# UNITED STATES PATENT AND TRADEMARK OFFICE

APPLICATION NO.	FILING DATE	FIRST NAMED INVENTOR	ATTORNEY DOCKET NO.	CONFIRMATION NO.
10/824,223	04/14/2004	Wen-Yen Lin	251702-1360	6290
24504	7590	01/24/2006	EXAMINER	
THOMAS, KAYDEN, HORSTEMEYER & RISLEY, LLP 100 GALLERIA PARKWAY, NW STE 1750 ATLANTA, GA 30339-5948			PAPE, ZACHARY	
			ART UNIT	PAPER NUMBER
			2835

<b>Office Action Summary</b>	Application No.	Applicant(s)	
	10/824,223	LIN ET AL.	
	Examiner	Art Unit	
	Zachary M. Pape	2835

## **DETAILED ACTION**

Fig 1

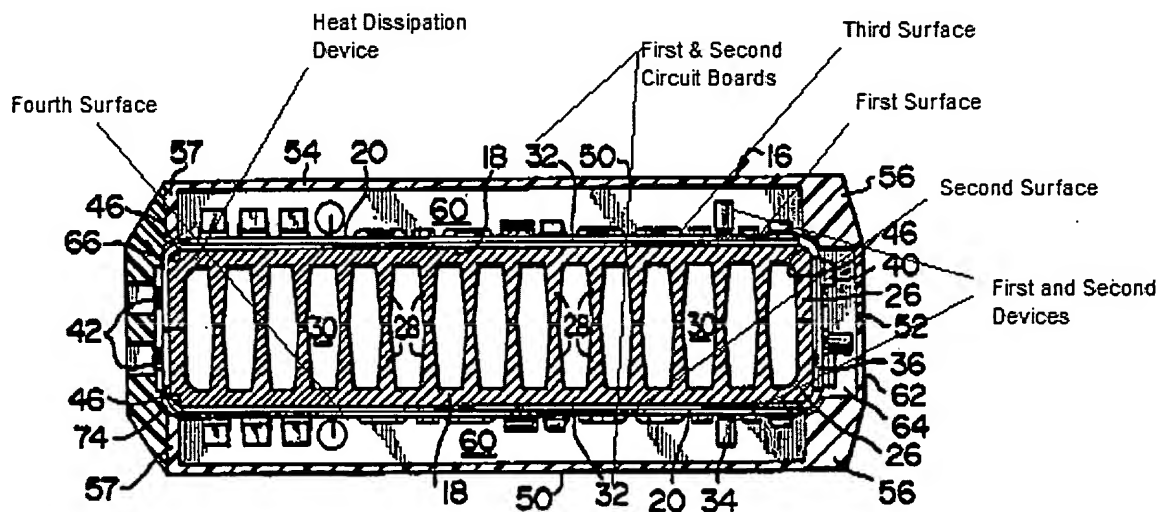
With respect to claim 1, Collins et al. teaches a function module comprising: a first circuit board (32) including a first surface (See present office action Fig 1 below); a second circuit board (32) coupled to the first circuit board (36, 38), including a second surface (See present office action Fig 1 below) facing the first surface; a plate-type heat dissipation device (12), disposed between the first circuit board and the second circuit board (As illustrated in Collins Fig 6). Collins et al. fails to teach a first ground layer formed on a first surface, a second ground layer on a second surface, and that the plate-type heat dissipation device abuts the first and second grounding layer. Nakamori teaches the conventionality of placing first (9) and second (3) ground layers onto respective surfaces on a pair of circuit boards. It would have been obvious to one of ordinary skill in the cooling art at the time the invention was made to place the ground layers (9, 3) of Nakamori on the first and second surfaces of the circuit boards of Collins et al. to provide a heat sink for dissipating heat from the heat generating components on the circuit board and onto the plate-type heat dissipation device (Nakamori Column 3, Lines 64-67).

With respect to claim 15, Collins et al. teaches a function module comprising: a first circuit board (32) including a first surface (See present office action Fig 1 above); a second circuit board (32), coupled to the first circuit board (Via 36, 38), including a second surface (See present office action Fig 1 above) facing the first surface, a plate-

type heat dissipation device (12), disposed between the first circuit board and the second circuit board (As illustrated in Fig 6). Collins et al. fails to teach a first heat conduction layer formed on a first surface, a second heat conduction layer on a second surface, and that the plate-type heat dissipation device abuts the first and second grounding layer. Nakamori teaches the conventionality of placing first (9) and second (3) heat conduction layers onto respective surfaces on a pair of circuit boards. It would have been obvious to one of ordinary skill in the cooling art at the time the invention was made to place the heat conduction layers (9, 3) of Nakamori on the first and second surfaces of the circuit boards of Collins et al. to provide a heat sink for dissipating heat from the heat generating components on the circuit board and onto the plate-type heat dissipation device (Nakamori Column 3, Lines 64-67).

With respect to claims 2 and 17, Collins et al. further teaches that the first circuit board further includes a third surface (See present office action Fig 1 above), opposite the first surface, with a first device (34) located thereon.

With respect to claims 3 and 18, Collins et al. further teaches that the second circuit board (32) further includes a fourth surface (See present office action Fig 1 above) opposite to the second surface, with a second device (34) located thereon.
